**ADDRESS:** 1667 EDISON

**APPLICATION NO:** #HDC-2024-00373

**HISTORIC DISTRICT:** BOSTON-EDISON

**SCOPE:** REPLACE WINDOWS, ALTER REAR PORCH, INSTALL VINYL SIDING

Front façade, left photo taken in early 2024 by Realcomp (included in real estate listing) and right photo taken by staff showing current condition/appearance after the recent unapproved work

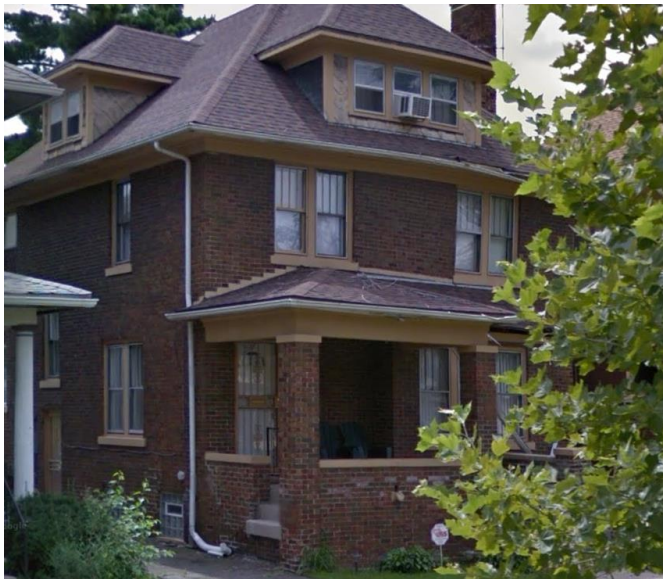
**Dormer has stucco front and sidewalls, retains original 4-light casement windows, and has wood soffits**

**4/1 wood windows throughout**

**1/1 vinyl windows with aluminum trim throughout**

**Dormer now clad with vinyl, windows are 1/1 vinyl units with aluminum trim, and vinyl soffit has been added**

**Porch and main roof have wood soffits**

**Vinyl soffit added to porch roof and main roof**

Rear porch, conditions prior to the current work on the left and after/current condition on the right. Photo provided by applicant.

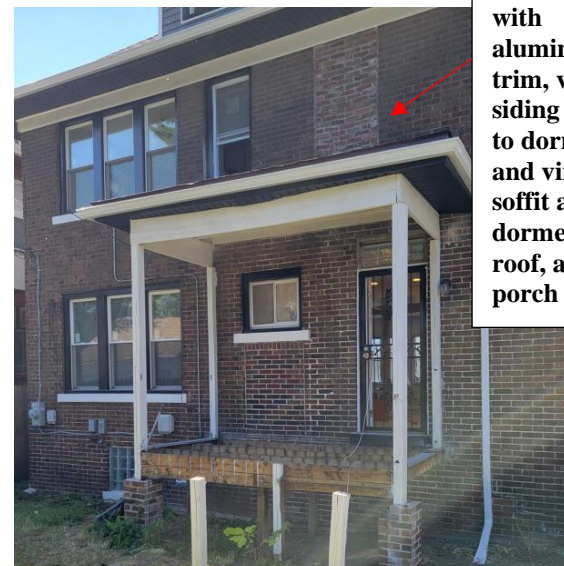
This porch was erected sometime after 1971 according to the below Sanborn Map

These columns should be reduced so that the height matches that of the balustrade's top rail

- At the new rear porch, the height of the southmost columns shall be reduced to a height that matches the top rail of the balustrade prior to the issuance of the project’s permit. It also shall be painted or stained an appropriate color within one calendar year.
- Regarding the proposed tuckpointing, the new mortar shall match the historic in color, texture, and composition/strength.

Rear wall conditions, prior to the current unapproved work on the left and after the unapproved work on the right. Photos provided by applicant

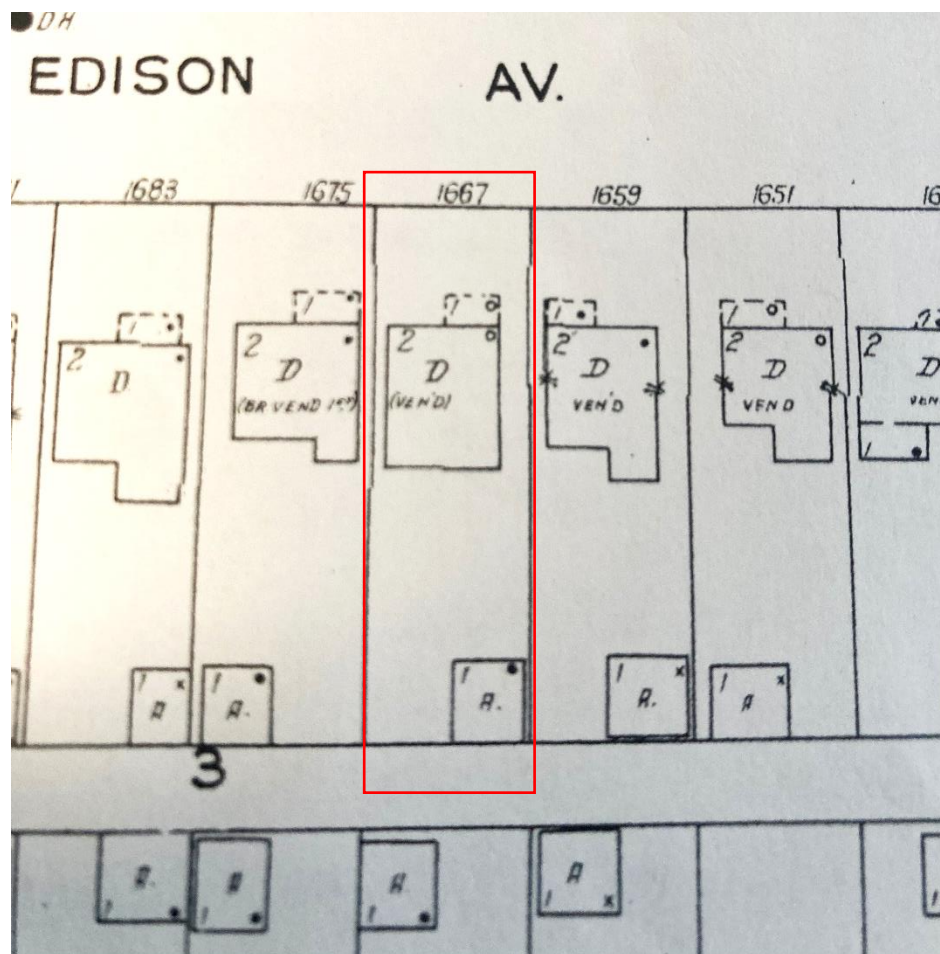
Wood siding at dormer and wood soffits at dormer and main roof

4 original windows at dormer and first story. 5 vinyl windows have been installed and one door opening above the porch has been infilled

All windows are 1/1 vinyl with aluminum trim, vinyl siding added to dormer, and vinyl soffit added to dormer. Main roof, and porch roof
